Technical Service Note 31-11

SUBJECT: Driveline Midship Support Crossmember Fasteners.

PRODUCTS: Cascadia vehicles equipped with a driveline center bearing midship support. Reference the following illustration:

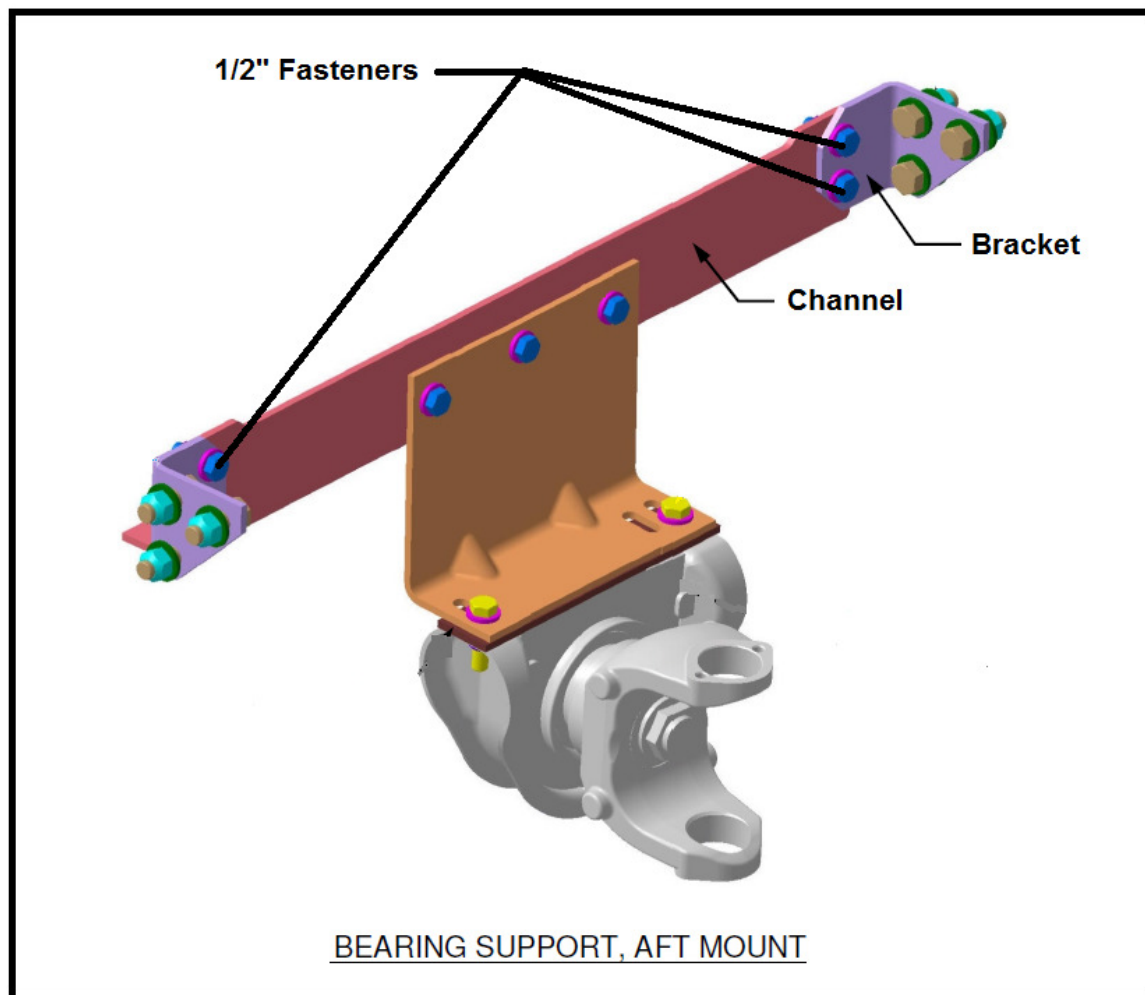
PROBLEM / SYMPTOMS: Customer complaints of loose fasteners at the bracket to channel bolted connection.

Inspect the four 1/2"-13 course thread fasteners that attach the channel to the gussets to confirm they are torqued to the appropriate specification.
Reference the following illustration:

If any of the fasteners are below the minimum torque, replace all four fasteners with new 1/2"- 20 fine thread hardware.

If there is any indication of slippage between the bracket and channel replace all four fasteners with new 1/2"- 20 fine thread hardware.

Note: Torque from the nut side to 64 ft-lbs.
